PD Modification Application: PRS 24-0627

**Hillsborough
County Florida**

Development Services Department

This application seeks to remove acreage from PD 22-0856 to become part of pending PD 23-0993. Additionally, a trip cap will be placed on the PD to ensure limited traffic generation for the subject PD and pending PD 23-0993, pending PD 23-0994, and pending PD 24-0031.

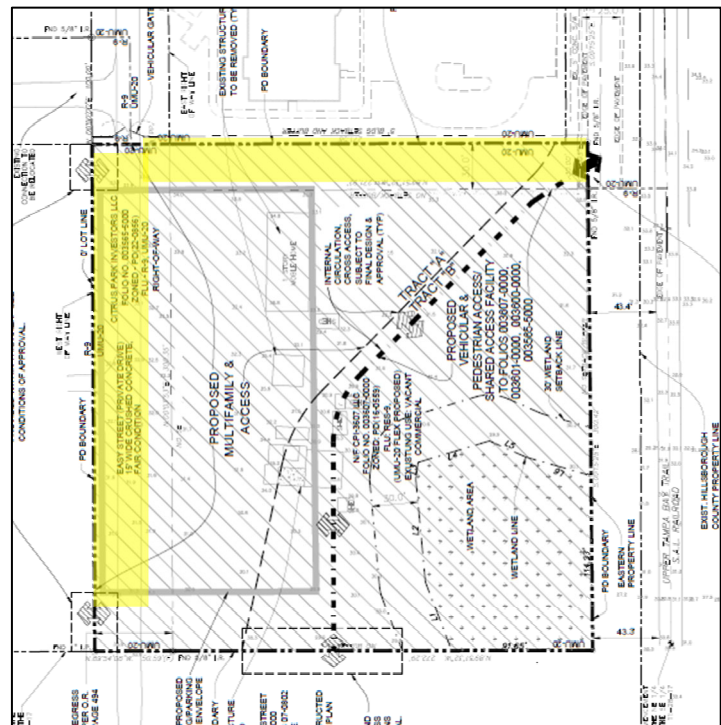
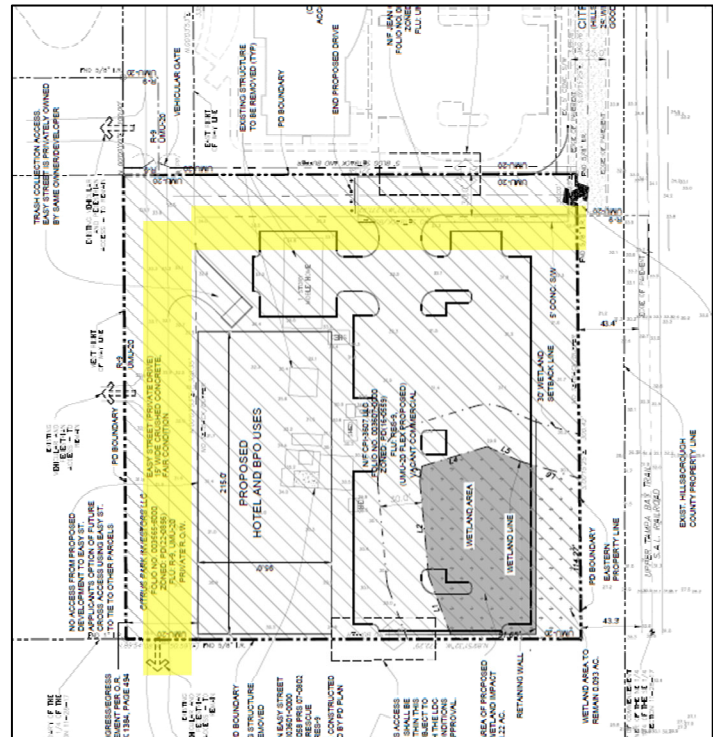
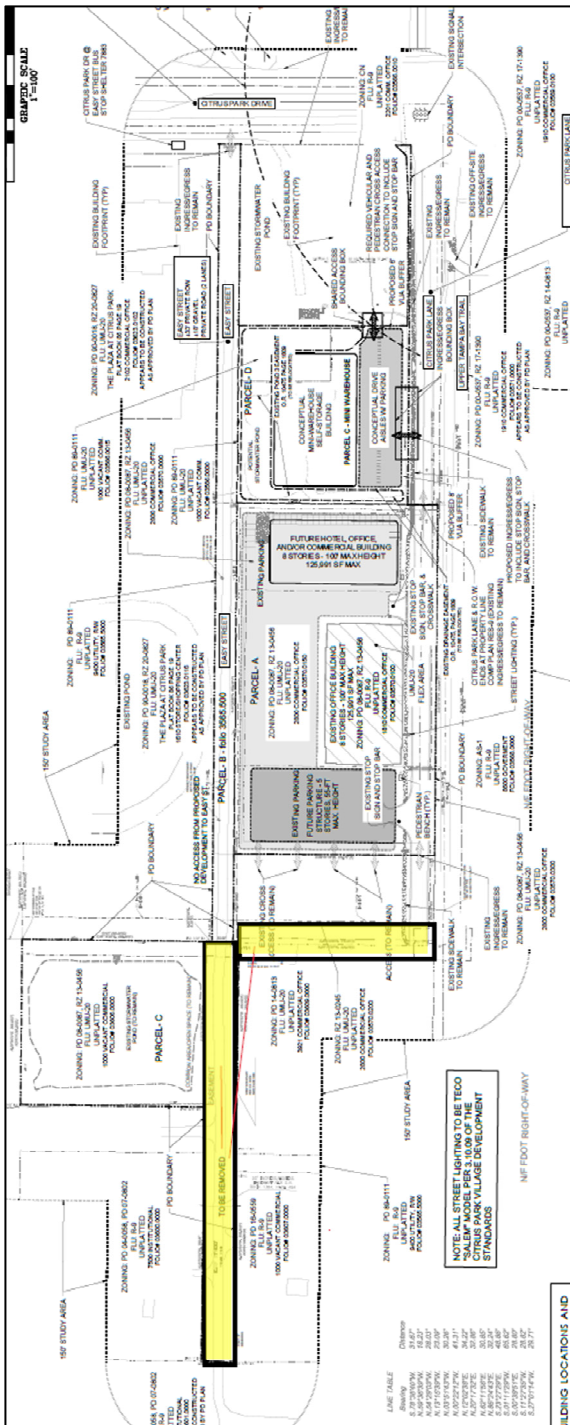
1. Site plan to remove Parcel C notation within Parcel D.
2. Futuresq to change to X.

PD 23-0993 & PD 23-0994 & PD 24-0031
Conceptual Location of Proposed Ramp Connection to Upper Tampa Bay Trail

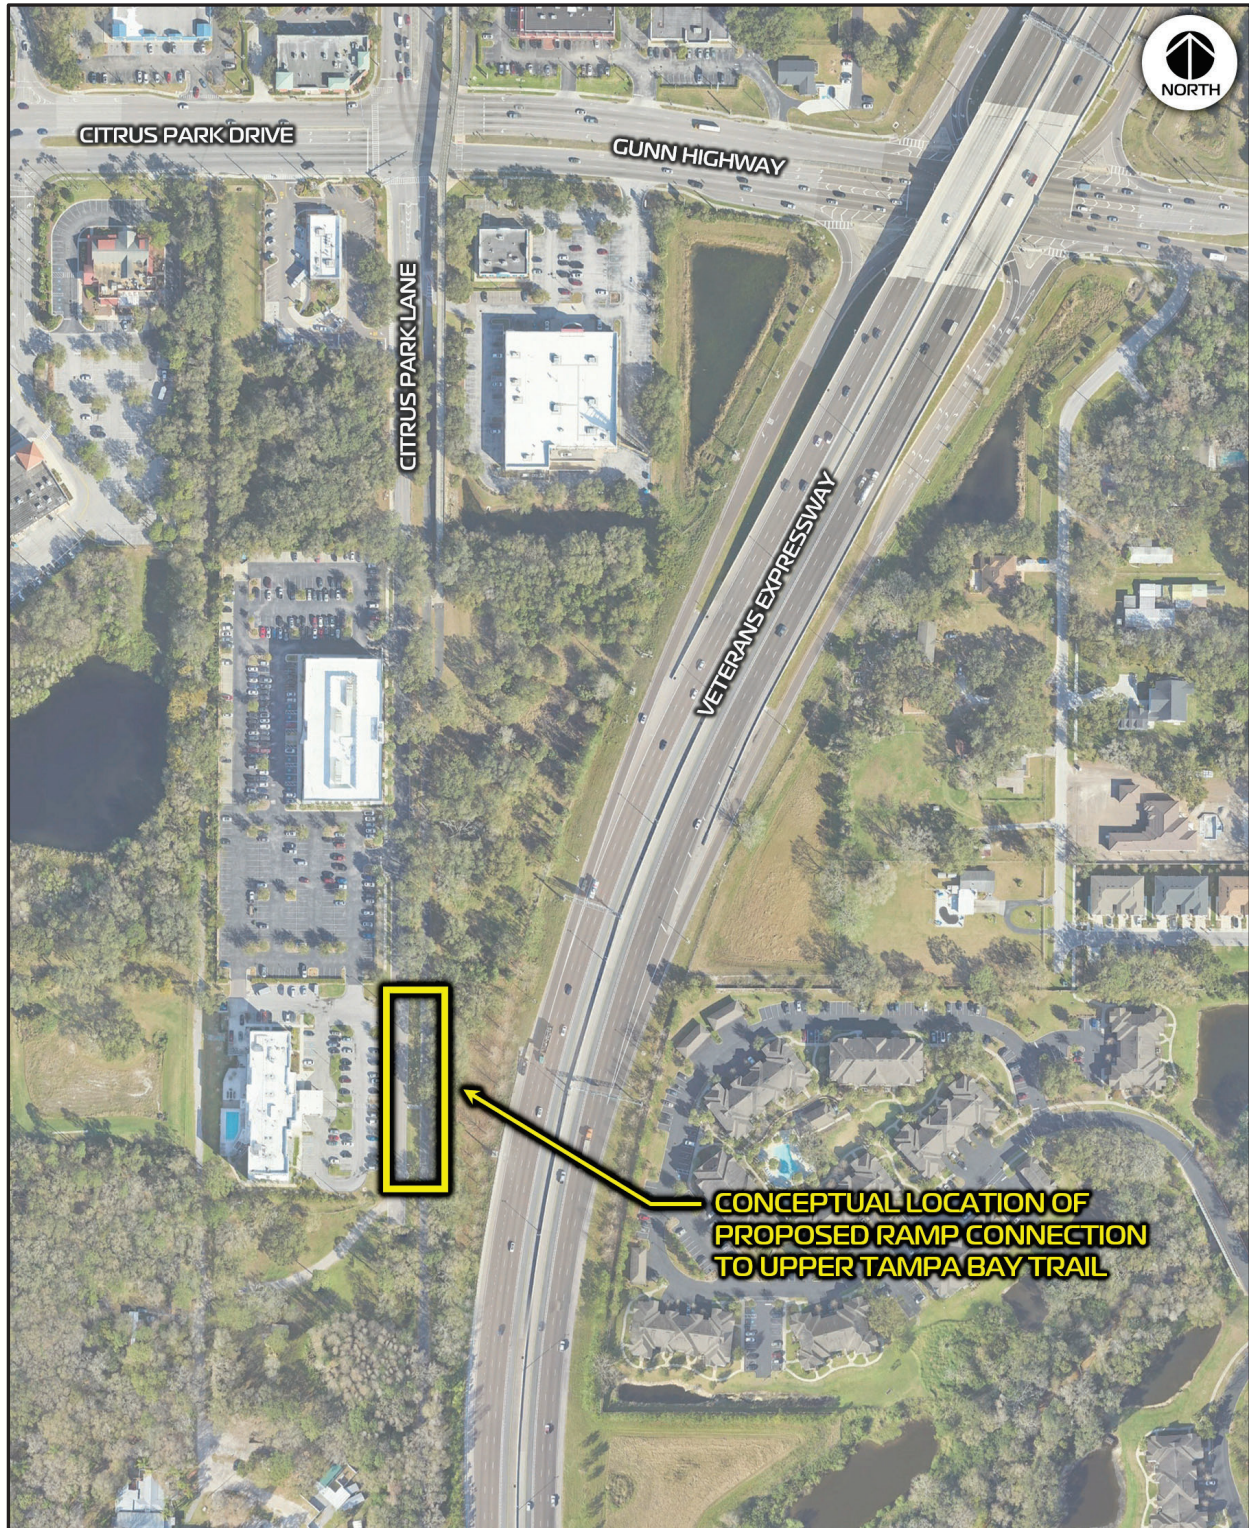
As alternative mitigation and to enhance safety along the roadway, the developer is proposing to construct a connection between the existing sidewalk system on the west side of Citrus Park Ln. and the UTBT, as generally shown on the PD site plan. The pedestrian crosswalk may occur at (or shall otherwise be in the general vicinity of) the existing staircase/connection to the UTBT located east of folio 3609.0000 unless otherwise necessary to meet vehicular sight distance standards to the newly constructed Citrus Park Ln. Extension.

The trail connection (which may be a new connection or a modification of the existing staircase connection) shall occur in whatever location is necessary to obtain approval and achieve a design which meets County and Americans with Disabilities Act (ADA) standards. This shall require the developer to install curb ramps on both the east and west sides of Citrus Park Ln. (including within a portion of folio 3609.0000). All of these required improvements are outside of the subject PD.

FIGURE 1
Intersection Improvements

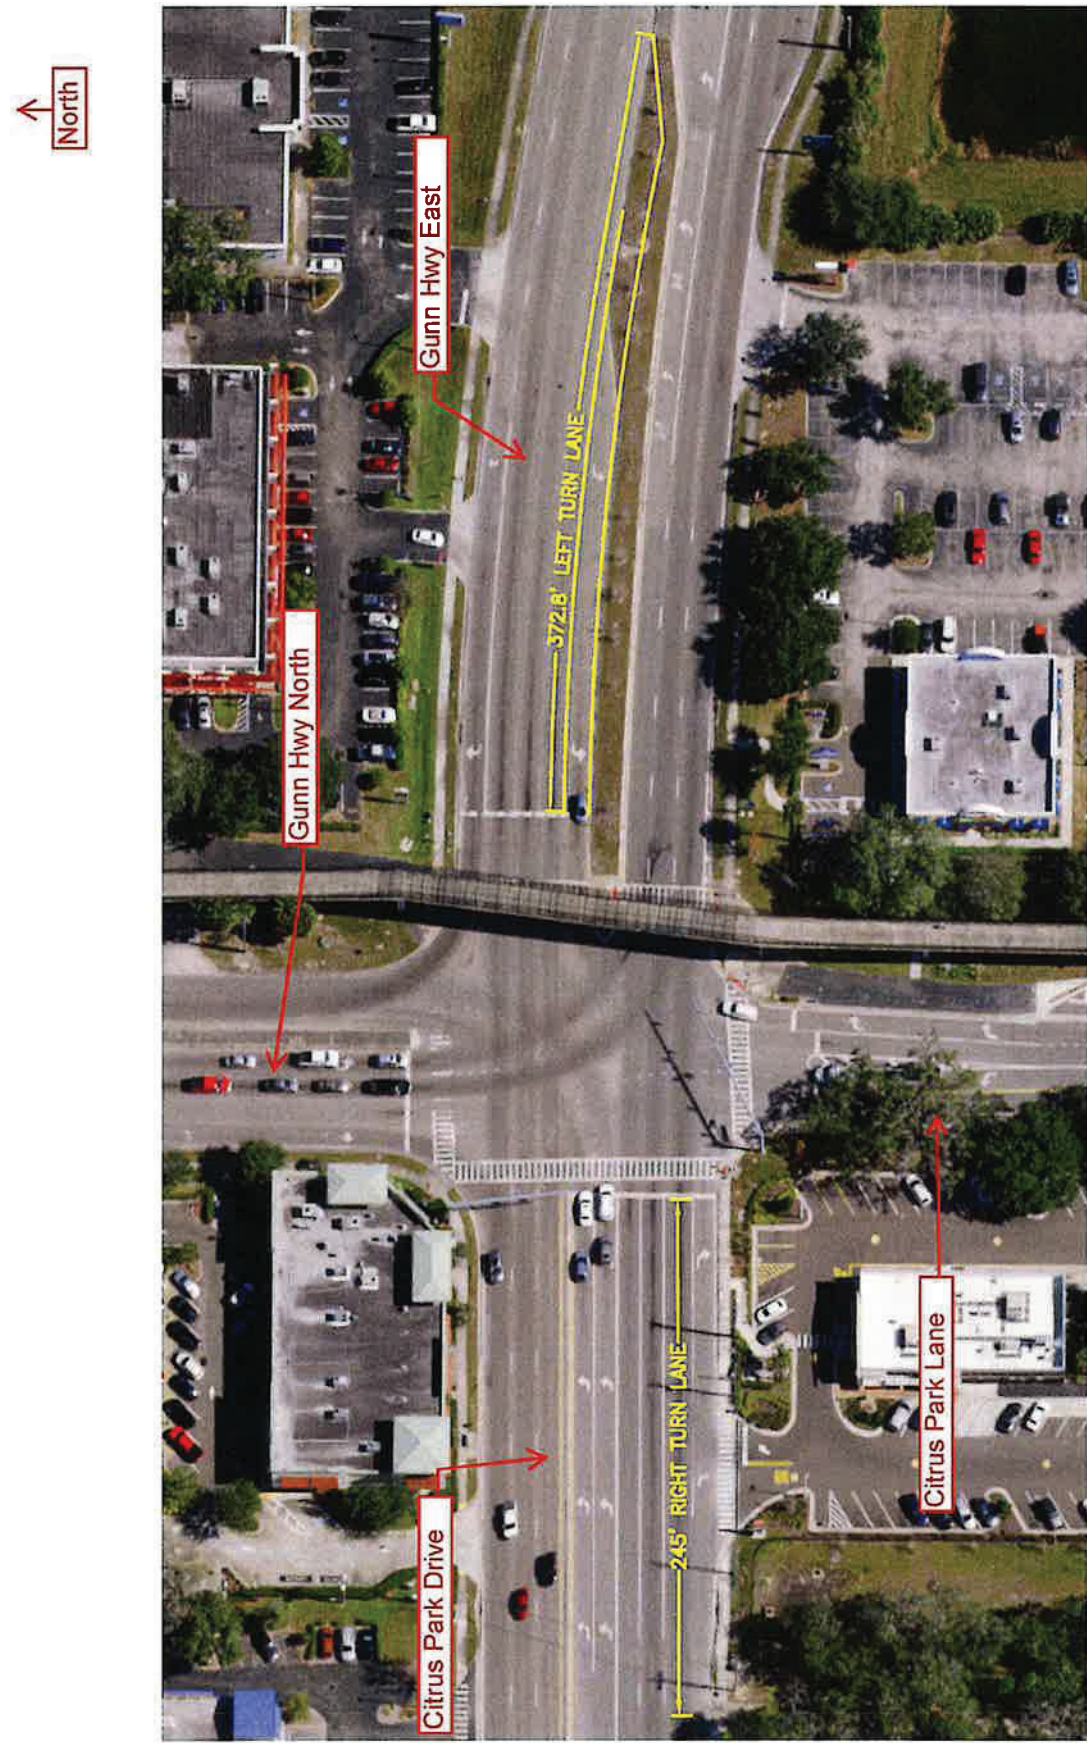
The existing westbound left turn lane is approximately 230 feet. In conjunction with the rezoning of these properties, the developers propose to extend the existing turn lane to approximately 372 feet, as shown in Figure 1.

As shown in Figure 1, the westbound left turn lane can be extended to approximately 372 feet which accommodates the 95th percentile queue for both scenarios. The turn lane can not be extended due to the eastbound left turn lanes for the Veterans Expressway Ramps.

- The applicant is proposing to reduce (by 113 feet) the required westbound to southbound left turn lane length, from a required length of 485 feet to a reduced length of 372 feet; and,
- The applicant is proposing to reduce (by 140 feet) the required eastbound to southbound right turn lane length, from a required length of 385 feet to a reduced length of 245 feet.

These Design Exceptions would require the developer to extend to the westbound to southbound turn lane to the length indicated above, while the existing eastbound to southbound right turn lane would be left in its existing condition.
